Subject: 06026 - Product Safety Recall
Power Steering Hose Separation

Models: 2006 Buick Lucerne with a V8 Engine (RPO LD8)
2006 Cadillac DTS

SUBJECT: Power Steering Hose Separation

MODELS: 2006 Buick Lucerne with a V8 Engine (RPO LD8)
 2006 Cadillac DTS

1683880

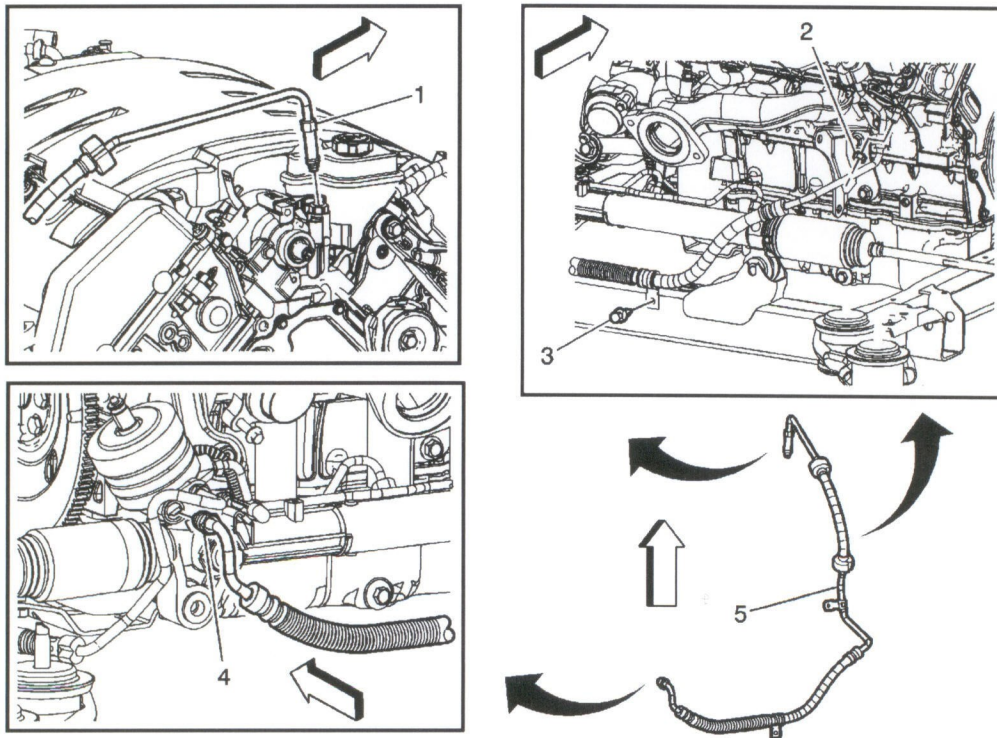
1. Install fender covers.
2. Install a drain pan under the vehicle.
3. Disconnect the power steering pressure hose (1) from the power steering pump.
4. Raise the vehicle as necessary to access the power steering hose fitting at the rack and pinion.
5. Remove the nut (2) retaining the power steering hose bracket at the cylinder head.
6. Disconnect the push pin (3) connecting the power steering bracket to the frame.
7. Remove 2 bolts from the steering gear heat shield and push the heat shield toward the engine, out of the way.
8. Disconnect the power steering hose (4) from the steering gear.
9. Drain and remove the power steering pressure hose from the vehicle.

10. Install the new power steering pressure hose to the vehicle.
11. Connect the power steering hose (4) to the steering gear.

12. Connect the power steering hose bracket to the frame with the push pin (3).
13. Install the power steering hose bracket nut at the cylinder head.

14. Position the steering gear heat shield and install the 2 bolts.

15. Lower the vehicle.
16. Install the power steering pressure hose (1) to the power steering pump.

Tighten the power steering pressure hose to the power steering gear to 27 N·m (20 lb ft).

Tighten the power steering pressure hose bracket retaining nut to 9 N·m (80 lb in).

Tighten the power steering gear heat shield bolts to 9 N·m (80 lb in).

Tighten the power steering pressure hose to the power steering pump to 27 N·m (20 lb ft).
